## **Authors' answer to the review of Schäfer et al. Simulations of primary and secondary ice production during an Arctic mixed-phase cloud case from the NASCENT campaign by anonymous referee no. 1**

## **Authors' answer to the review of Schäfer et al. Simulations of primary and secondary ice production during an Arctic mixed-phase cloud case from the NASCENT campaign by anonymous referee no. 2**

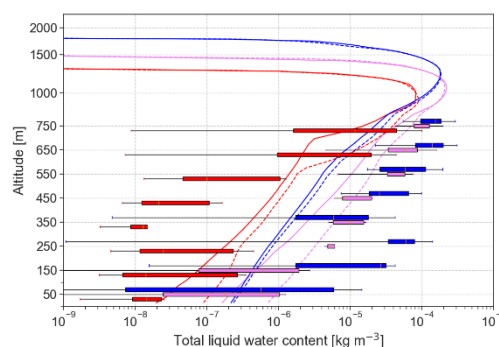
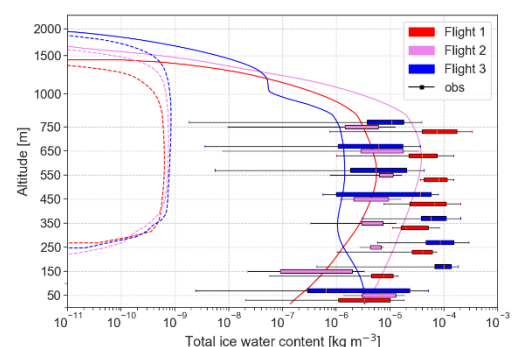
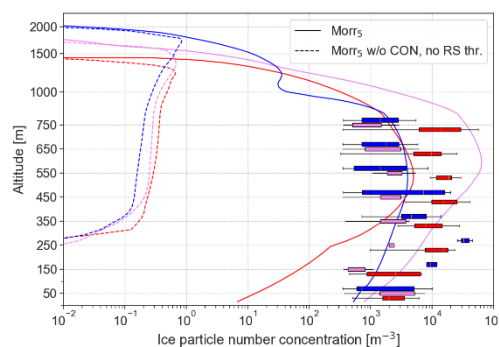
- **Run without contact nucleation:** The authors should re-run the simulations with contact nucleation turned off. In sentence 193, the authors say "we use the contact freezing parameterization by Young (1974), as no measurements of INPs in the contact freezing mode were conducted." This contradicts an earlier sentence on 116, which says "If the

concentration of the newly formed ice crystals is larger than the INPC, it can be concluded that SIP was occurring.” In choosing to leave contact nucleation in the simulations, the authors are positing that contact nucleation is occurring in the real atmosphere but is not reflected in the measurements of INPC. Therefore, if there are more ice crystals than measured INPC, it can not in fact be concluded the SIP is occurring; those “extra” ice crystals could have been formed through contact nucleation. It also, in my opinion, contradicts the sentence in lines 137-139 which says that the modification to immersion freezing “permits a correct quantification of heterogeneous cloud particle formation and also ensures that an agreement of the modeled cloud particle concentrations with observations is accomplished through the correct process,” because there is still a heterogeneous nucleation process that has not been constrained in any way with observations. I think keeping contact nucleation active somewhat defeats the purpose of having modified the immersion freezing to be more realistic. Fortunately, there is little evidence for contact nucleation actually occurring in the real atmosphere and, for this reason, it is turned off by default in the P3 scheme, which has otherwise similar ice nucleation as Morr. I think the authors can justify turning it off here and then would be more easily able to make the case that they have constrained the heterogeneous ice nucleation with observations to the best of their ability.

It is indeed a good suggestion to try what happens in the model when no contact INPs are present. We did that for the Morr<sub>5</sub> simulation where SIP is most efficient, but found that the ice concentrations are drastically lower than when contact nucleation is active. To be sure that ice production is not hindered by the remaining mixing ratio thresholds for RS, we also performed one additional simulation with the microphysics settings as in Morr<sub>5</sub>, but without contact freezing and with all mixing ratio thresholds for RS removed. Even in this case, the ICNC is so far from the observations, that we find it more meaningful to keep contact freezing active in the model than turning it off (see Figure below).

Taking Fig. 8a from the manuscript into account (previously 10a), which shows that contact freezing contributes at a larger range of times and altitudes than immersion freezing (even though at smaller rates), this was not completely surprising. From our observations, we can't tell whether the simulated contact freezing represents what is happening in nature, but support the quest for further observations-based information on contact nucleation. In case contact nucleation is not occurring in nature (as literature suggests), the strength/efficiency of SIP processes needs to be increased.

We added the finding, that ICNC was reduced drastically when disabling contact freezing, in the text in section 3.1 where modifications in the Morr scheme are discussed (line 232-237 in revised manuscript):

“Even though it is questionable to which extent contact freezing is actually occurring in the atmosphere (Ladino Moreno et al., 2013; Marcolli et al., 2016; Nagare et al., 2016), a sensitivity test with the Morr scheme (not shown) revealed that without contact freezing active and with immersion freezing parametrized after (Pasquier et al., 2022a) as the only heterogeneous ice nucleation process, simulated ice crystal concentrations were far lower than observed. An agreement could not be achieved by adding SIP the way it is done in this study. Therefore, we decided to keep contact freezing active (see also Sect. 4.5).”
